# **2024 JAPANESE GRAND PRIX**

<b>From</b>	The FIA Formula One Media Delegate	<b>Document</b>	12
<b>To</b>	All Teams, All Officials	<b>Date</b>	05 April 2024
		<b>Time</b>	08:47

## Title Car Presentation Submissions

## Car Presentation – Japanese Grand Prix ORACLE RED BULL RACING

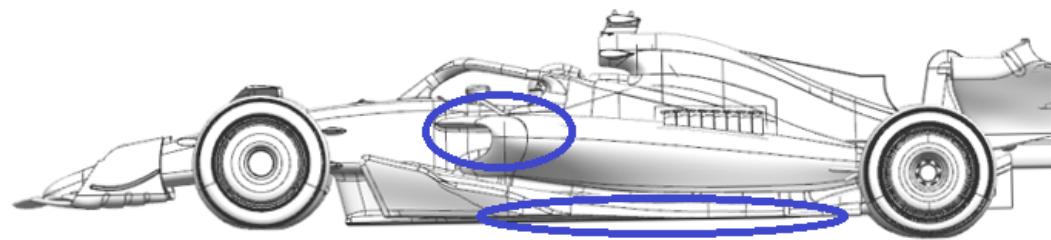
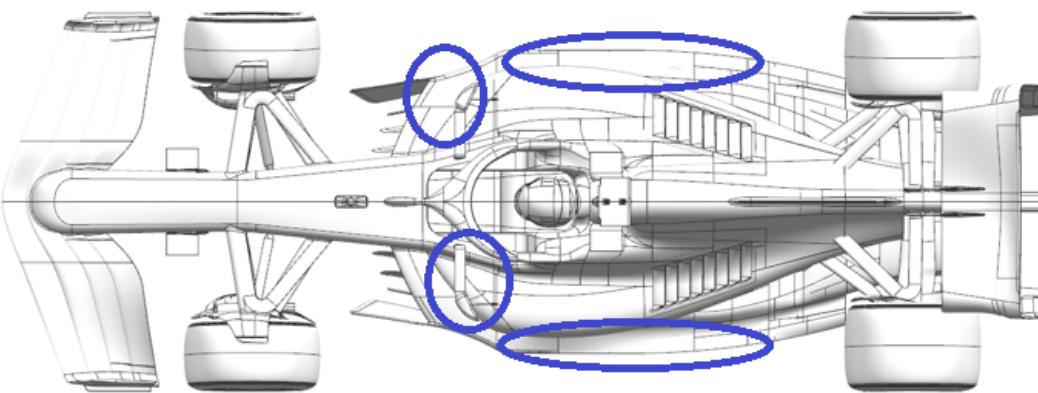
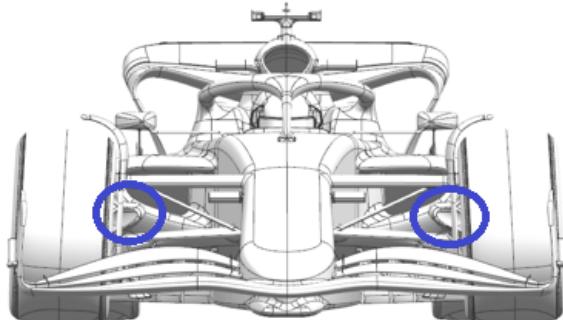
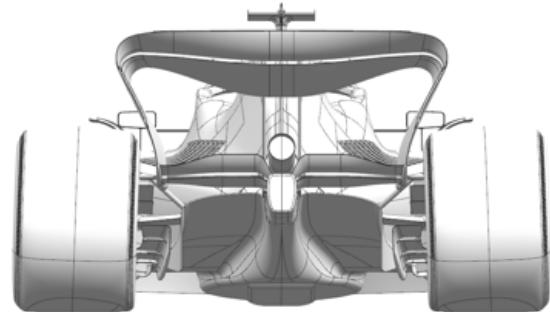
<b>Updated component</b>	<b>Primary reason for update</b>	<b>Geometric differences compared to previous version</b>	<b>Brief description on how the update works</b>
1	Sidepod Inlet	Performance - Local Load	Redistributed inlet areas for the sidepod mounted primary heat exchangers	seeking the most efficient locations in terms of pressure inlet for the area, we then need less exit area which is beneficial downstream.
2	Floor Body	Performance - Local Load	further optimisation of the floor surface incurring no mechanical changes above the floor	with better understanding of the pressure distribution, subtle surface changes have exploited the flow characteristics to extract more load locally whilst maintaining flow stability
3	Floor Edge	Performance - Local Load	Increased camber and plan view area.	given knowledge of the flow and pressure feeding the floor edge wing, more camber has been applied to generate more local load whilst maintaining an adequate level of stability.

4	Front Corner	Circuit specific - Cooling Range	Smaller inlet and exit ducts for the front brakes with re-optimised locally geometries to accommodate	The low brake energy demands of Suzuka allow a reduction of inlet and therefore exit ducts which is more efficient than blanking the ducts used at earlier events.

## SCUDERIA FERRARI

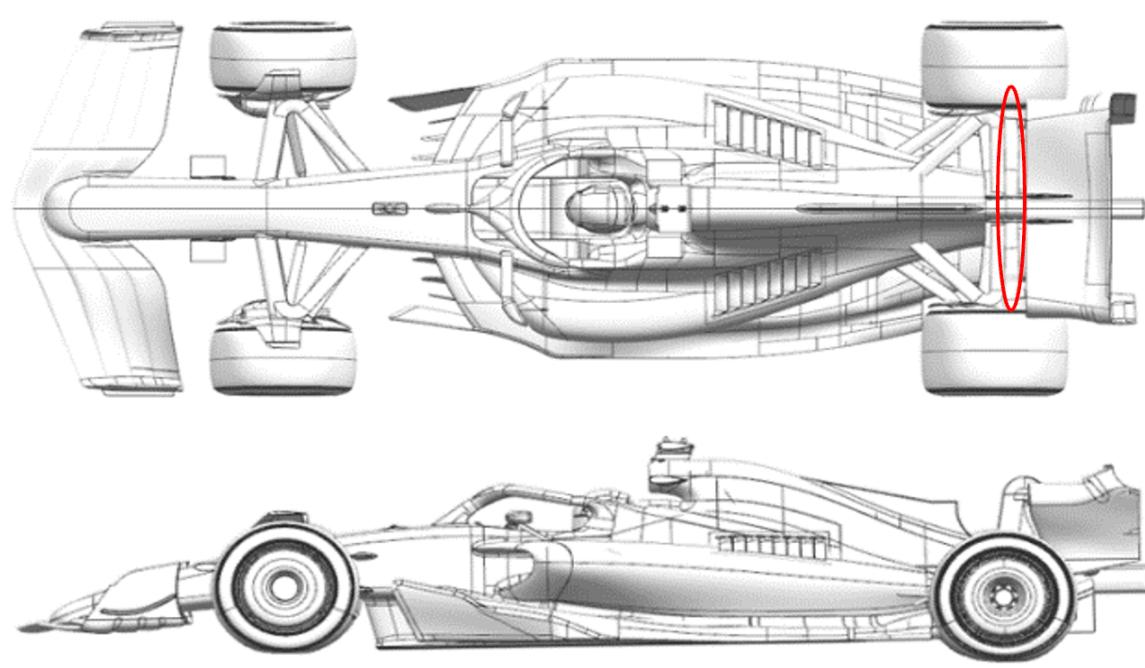
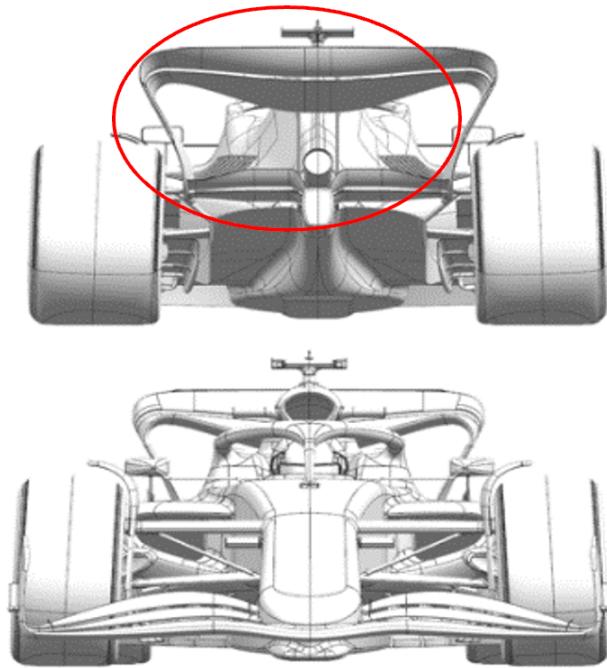
<b>Updated component</b>	<b>Primary reason for update</b>	<b>Geometric differences compared to previous version</b>	<b>Brief description on how the update works</b>
1	Rear Wing	Circuit specific - Drag Range	Higher Downforce Top Rear Wing and Lower Beam Wing designs	Anticipating possible rain and low grip conditions, a more loaded top rear wing together with a more loaded lower beam wing, fully carried over designs from 2023, will be part of the downforce selection pool for this event.
2	Rear Suspension	Performance - Flow Conditioning	Reprofiled rear top wishbone rearward leg fairing	Not specific to the Suzuka circuit layout, this minor rear suspension fairing upgrade features a longer chord profile, with local flow conditioning improvements and positive interaction with surrounding components, bringing a small efficiency increase.

## MCLAREN FORMULA 1 TEAM

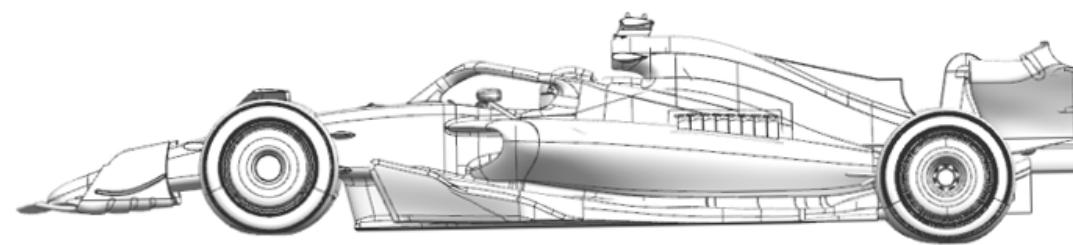
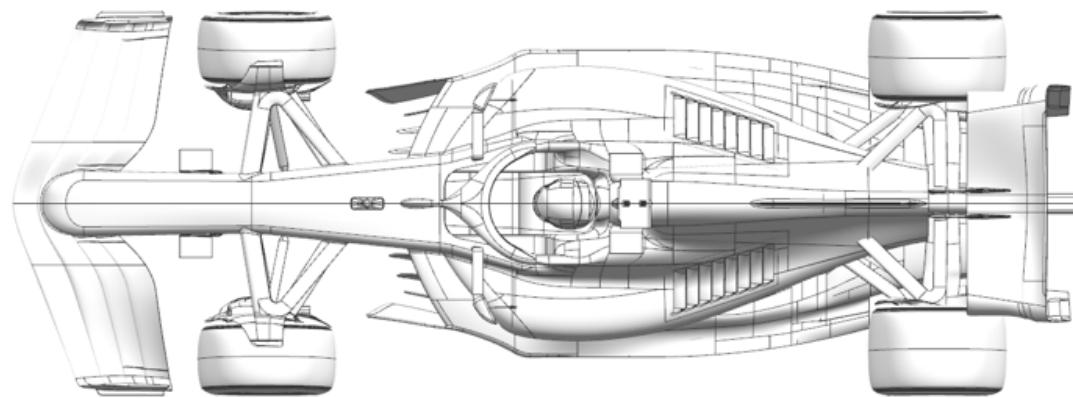
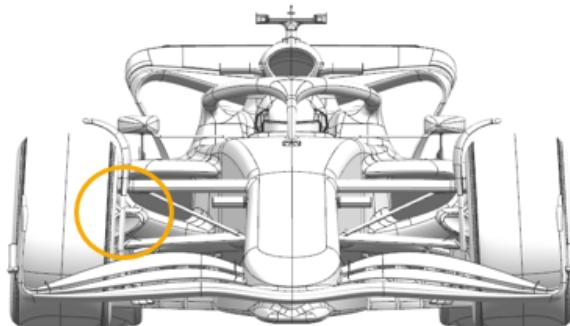
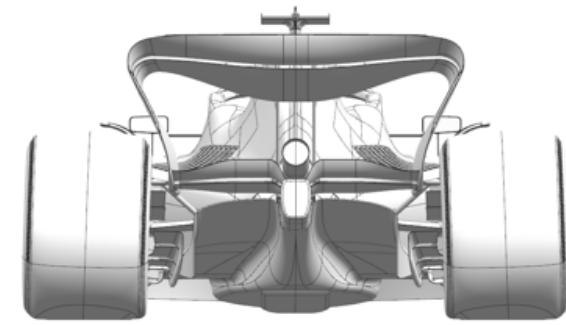
<b>Updated component</b>	<b>Primary reason for update</b>	<b>Geometric differences compared to previous version</b>	<b>Brief description on how the update works</b>
1	Front Corner	Circuit specific - Cooling Range	Low Cooling Front Brake Duct	As this circuit features reduced brake cooling requirements, the front brake duct geometry has been modified trading brake cooling massflow for aerodynamic performance.

### ASTON MARTIN ARAMCO FORMULA ONE TEAM

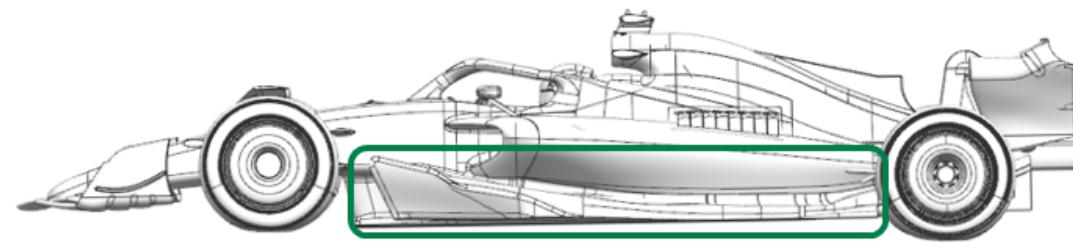
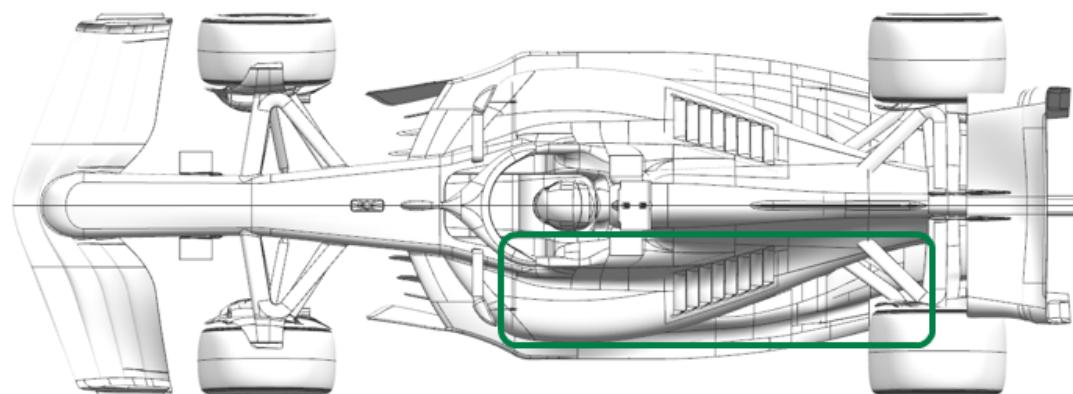
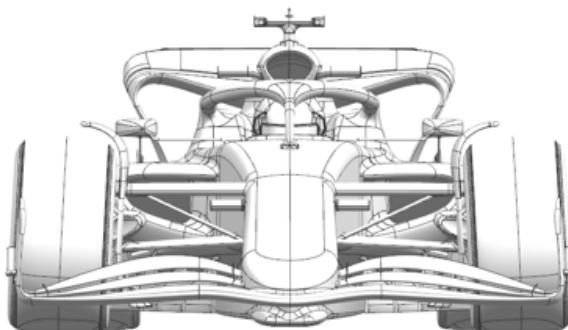
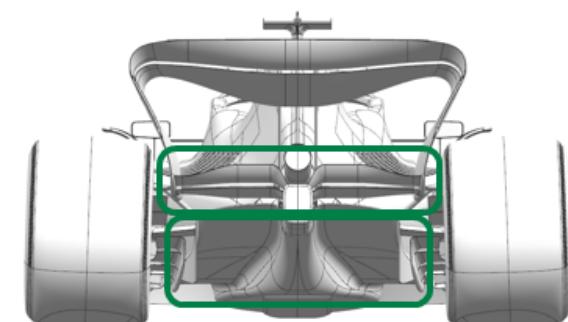
<b>Updated component</b>	<b>Primary reason for update</b>	<b>Geometric differences compared to previous version</b>	<b>Brief description on how the update works</b>
1	Floor Body	Performance - Local Load	The main body of the floor has evolved slightly with the fences and floor edge.	The revised shapes improve the flowfield under the floor increasing the local load generated on the lower surface and hence performance.
2	Floor Fences	Performance - Local Load	The fences are redistributed across the LE of the floor with revised curvature.	The revised shapes improve the flowfield under the floor increasing the local load generated on the lower surface and hence performance.
3	Floor Edge	Performance - Local Load	The chord of the floor edge wing is reduced compared to the previous version.	The revised shapes improve the flowfield under the floor increasing the local load generated on the lower surface and hence performance.

4	Diffuser	Performance - Local Load	The diffuser is a slightly modified shape with revised top surface.	The changes to the shape modify the expansion in the diffuser to improve flow characteristics and the load generated on the surfaces.

### BWT ALPINE F1 TEAM

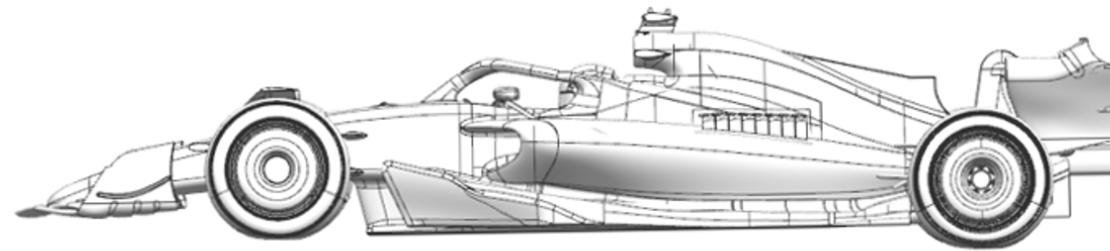
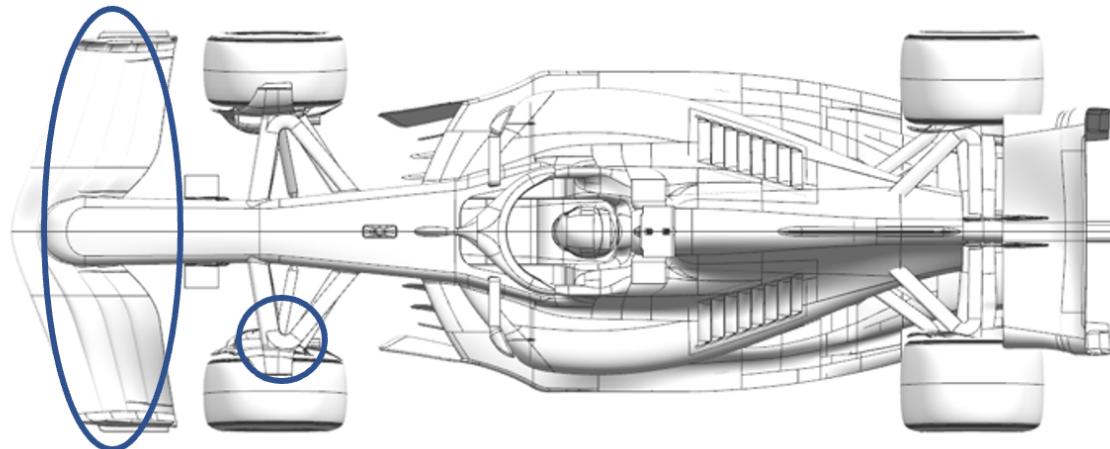
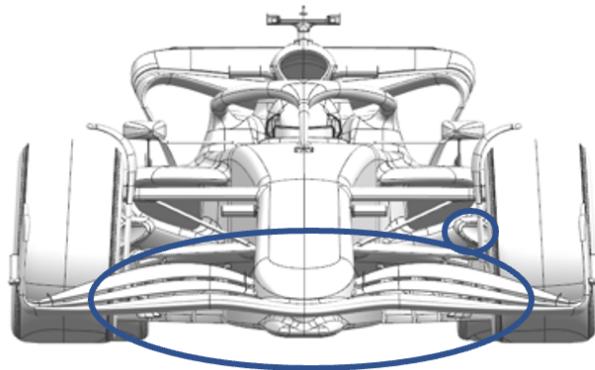
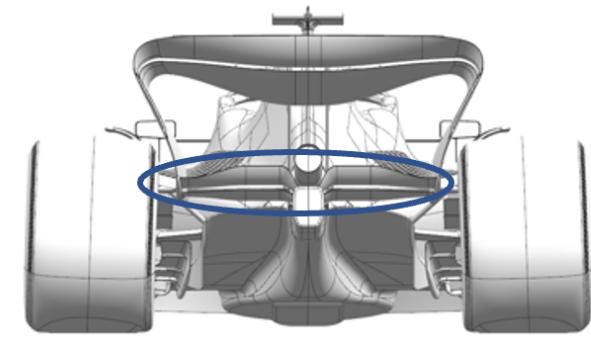
<b>Updated component</b>	<b>Primary reason for update</b>	<b>Geometric differences compared to previous version</b>	<b>Brief description on how the update works</b>
1	Front Wing	Performance - Drag reduction	New shape of all front wing elements and new end plate arrangement.	More offloaded outboard front wing which gives an efficient drag saving compared to the previous wing.
2	Front Corner	Performance - Flow Conditioning	Revised ducting arrangement of the front brake drum.	Makes better use of the inlet flow in conjunction with the aforementioned new front wing compared to the previous version.
3	Beam Wing	Performance - Local Load	Traditional non-biplane rear beam wing.	Offloads the beam wing and top rear wing to increase load in the floor compared to the previous version.

## WILLIAMS RACING

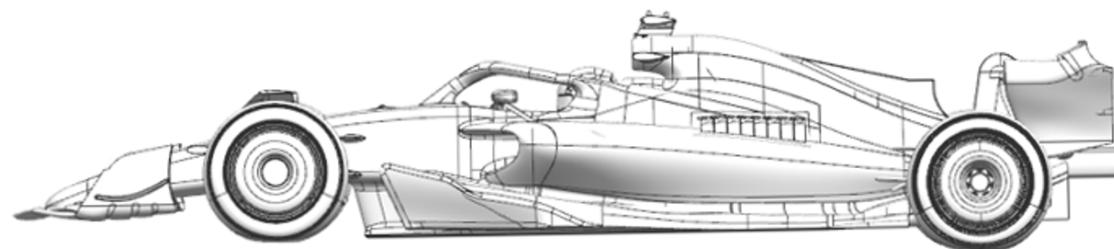
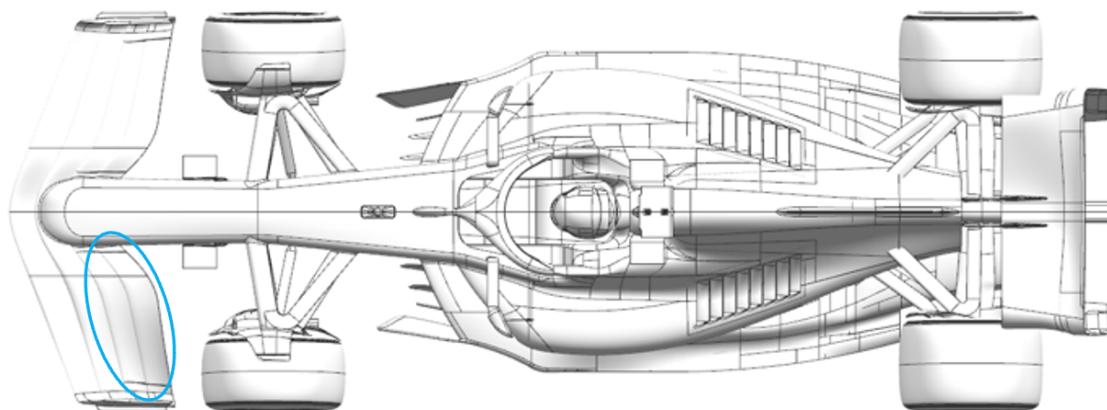
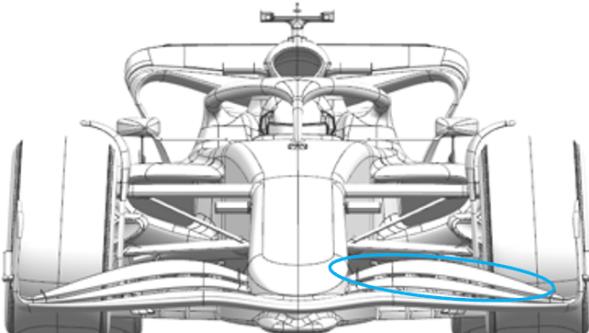
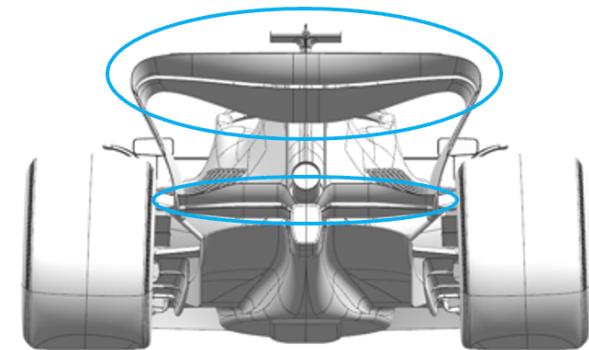
<b>Updated component</b>	<b>Primary reason for update</b>	<b>Geometric differences compared to previous version</b>	<b>Brief description on how the update works</b>
1	Front Wing Endplate	Performance - Flow Conditioning	The rearmost 2 elements are reprofiled and their junction with the endplate is heavily modified.	The updated geometry changes the control of the front tyre flow structures. This affects the flow field further rearward on the car, improving both the overall downforce of the car and the characteristics of the downforce delivery.
2	Rear Wing	Circuit specific - Drag Range	This rear wing has smaller upper elements.	These revised wing elements provide an efficient drop in downforce and drag. They work with the new beam wing to directly lower the load generated by the rear wing assembly. This is an optional setup for this weekend.
3	Beam Wing	Circuit specific - Drag Range	The new beam wing has a small area than the previous version.	These revised beam wing provides an efficient drop in downforce and drag. It works with the new upper wing elements to directly lower the load generated by the rear wing assembly. This is an optional setup for this weekend.

## VISA CASH APP RB FORMULA ONE TEAM

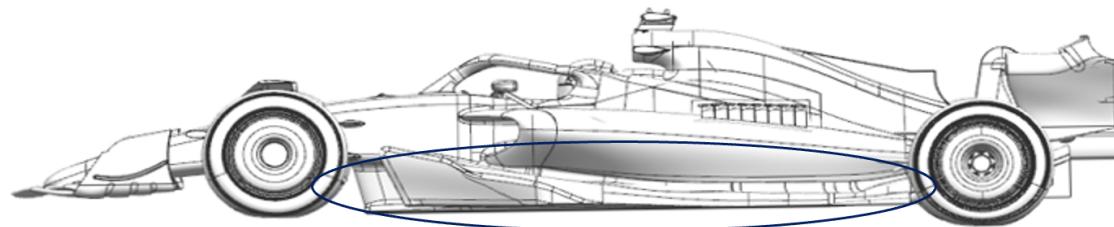
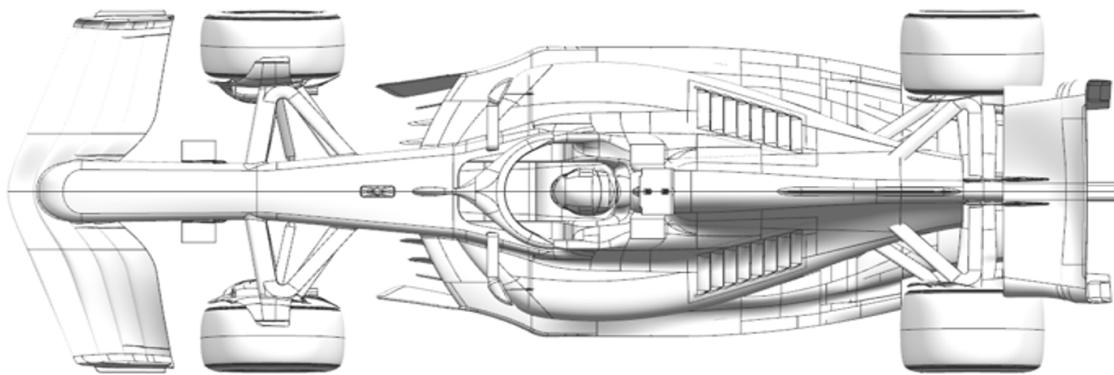
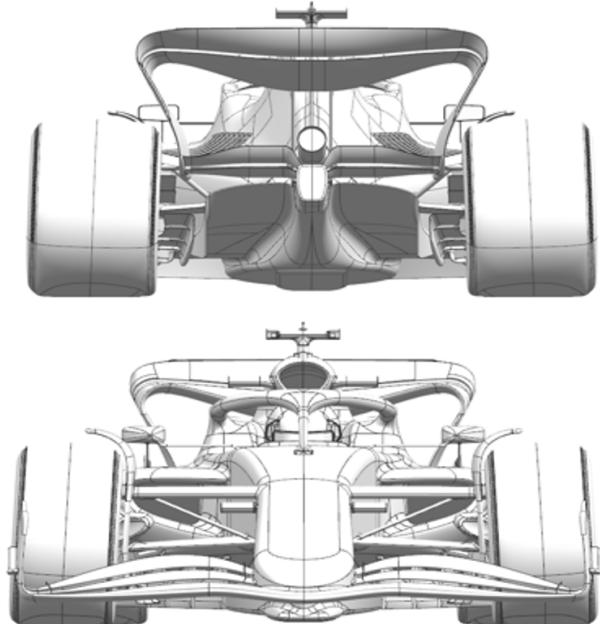
<b>Updated component</b>	<b>Primary reason for update</b>	<b>Geometric differences compared to previous version</b>	<b>Brief description on how the update works</b>
1	Floor Body	Performance - Local Load	The profiles of the floor fences and the shape of the underfloor have been updated.	All of the underfloor changes achieve greater local load from the underfloor whilst maintaining or improving the flow quality downstream.
2	Floor Edge	Performance - Local Load	The profile & incidence of the Floor Edge & wing has been modified.	In combination with the above changes, the Floor Edge Wing has been modified to increase loading of the underfloor.

### STAKE F1 TEAM KICK SAUBER

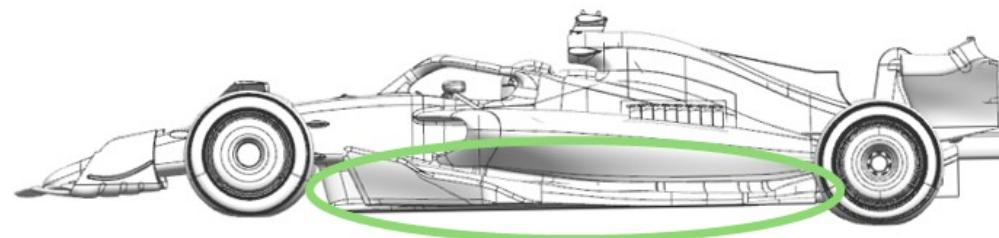
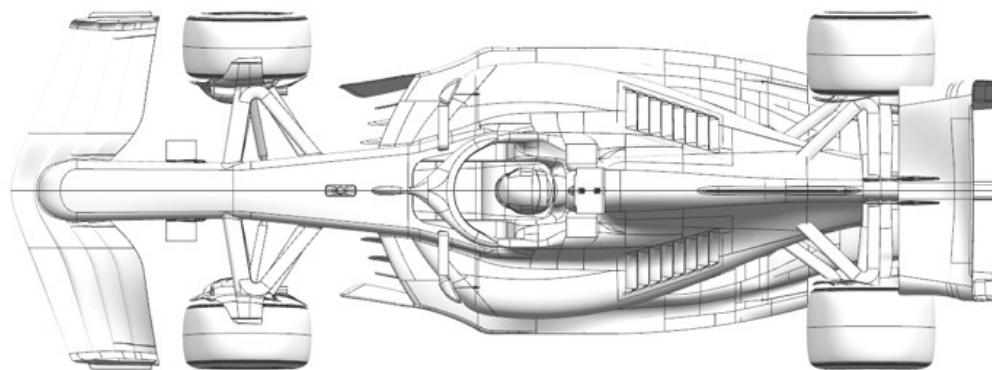
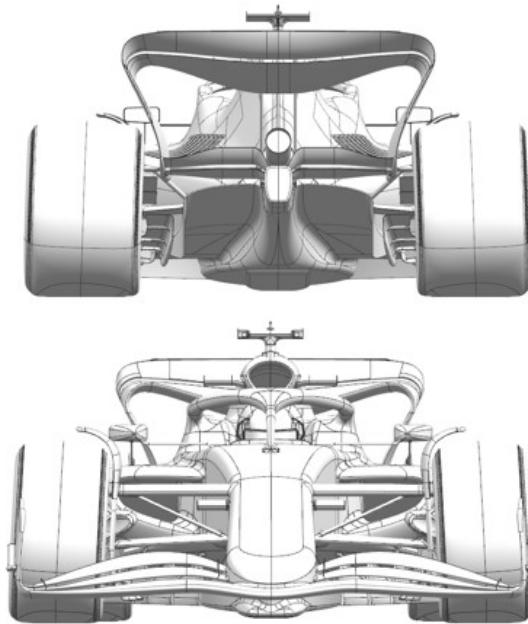
<b>Updated component</b>	<b>Primary reason for update</b>	<b>Geometric differences compared to previous version</b>	<b>Brief description on how the update works</b>
1	Floor Body	Performance - Flow Conditioning	New design of the floor body and edges, mostly in the front and middle sections	The new floor, with extended fences and redesigned front and middle parts, improves the airflow and the stability of the car, improving aerodynamic efficiency of the whole package.
